APPENDIX A

Agency Coordination

Re: *Benton Solar Energy Project, Benton County, Minnesota*

Proposed Benton Solar with Public Waters

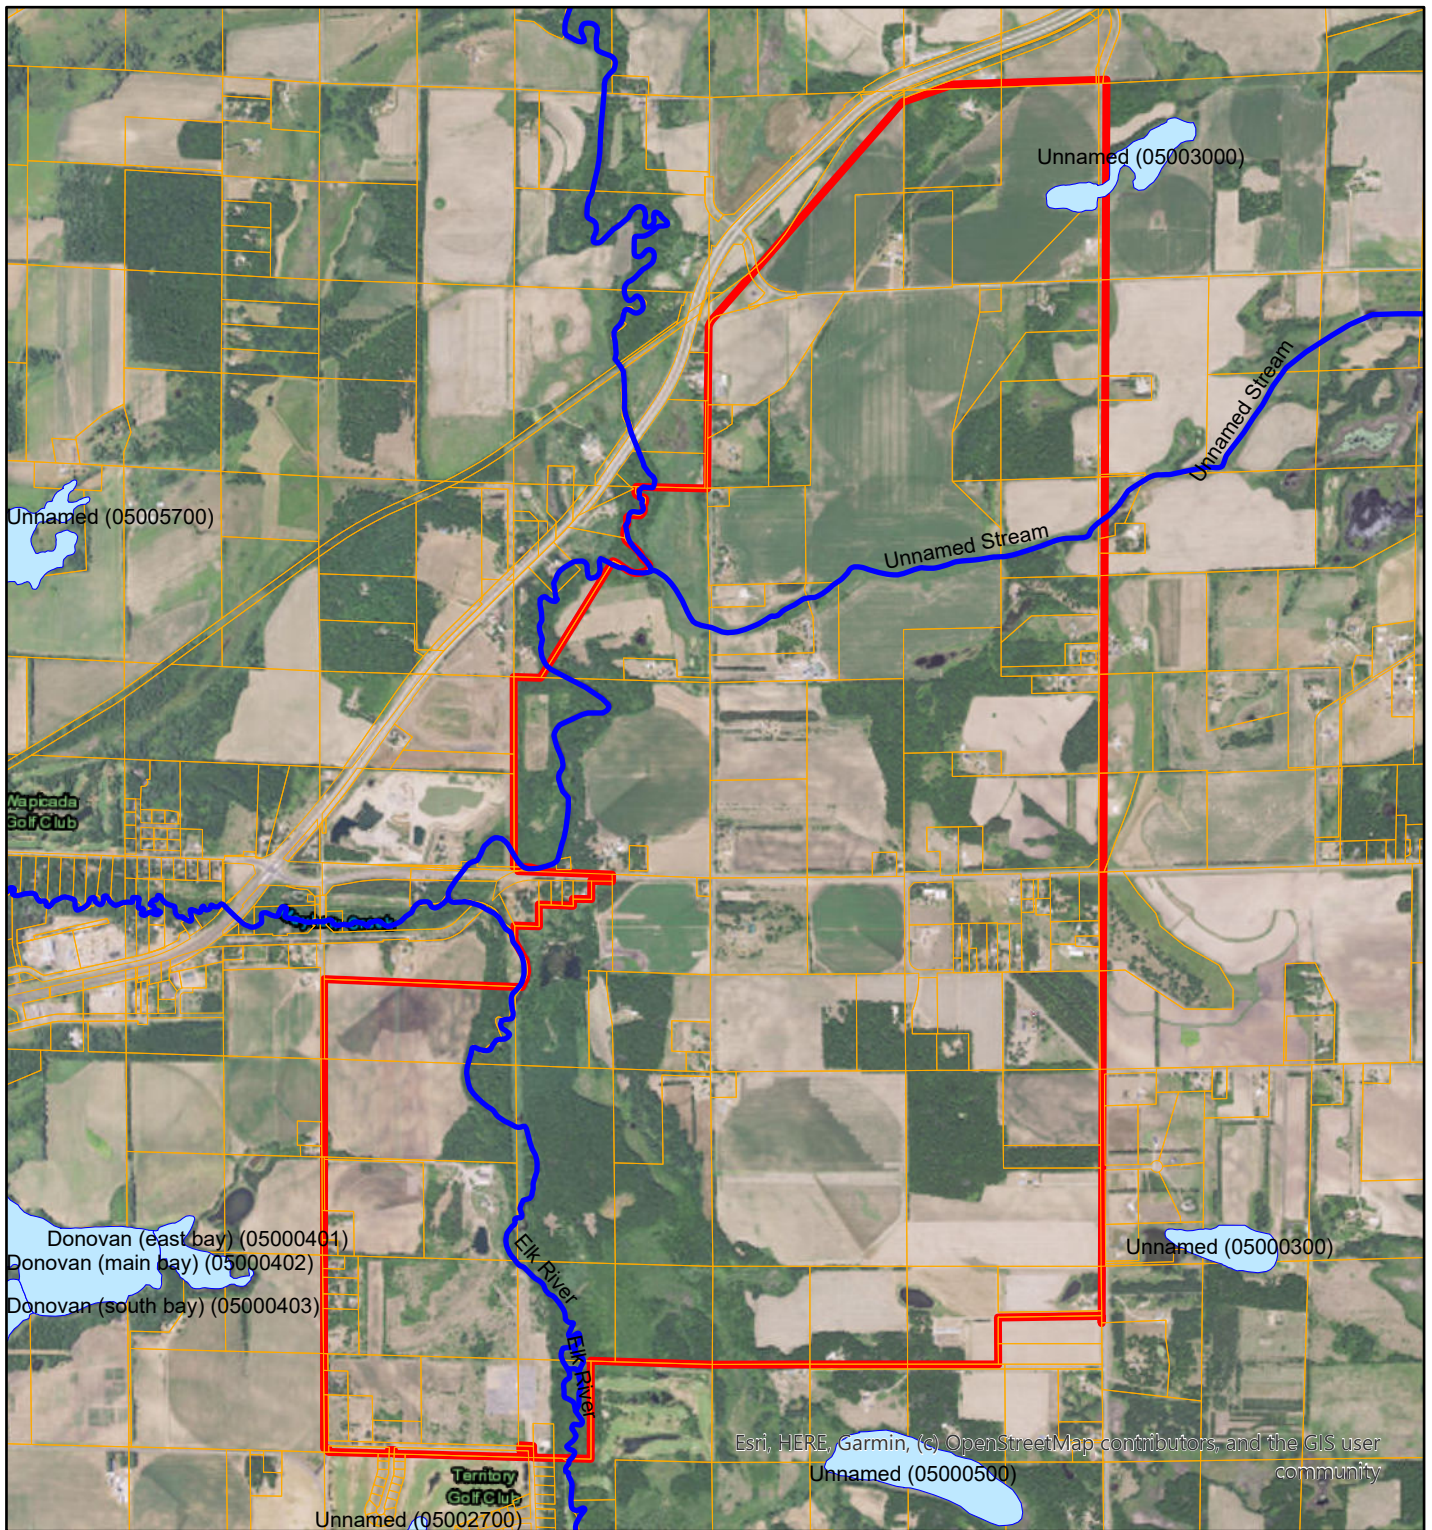
Also, there is not enough or the right type of information to allow us to pre-review the proposal as provided. There is no information on where the infrastructure is going to be or how power will be routed off the site, therefore, I don't know if you will need to apply for utility crossing licenses or not.

I am attaching a map that reflects the outline of the 3,000-plus acres you are indicating as the project area, along with an overlay three public watercourses within the area, and one or two lakes. If there are crossings of any of these watercourses, utility licenses will be required.
